Product Discontinuation

Model FH-SC

Model FH-SM

Recommended Replacement

[Dimensions]

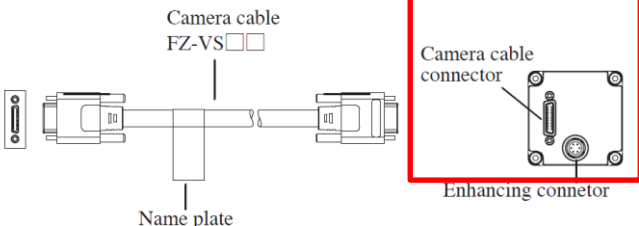
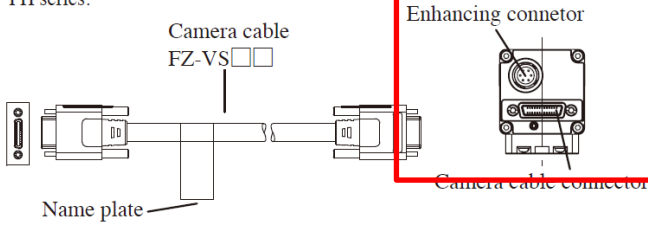
It's different in dimensions, so reconsideration of the installation environment according to the specification of the camera after change, please.
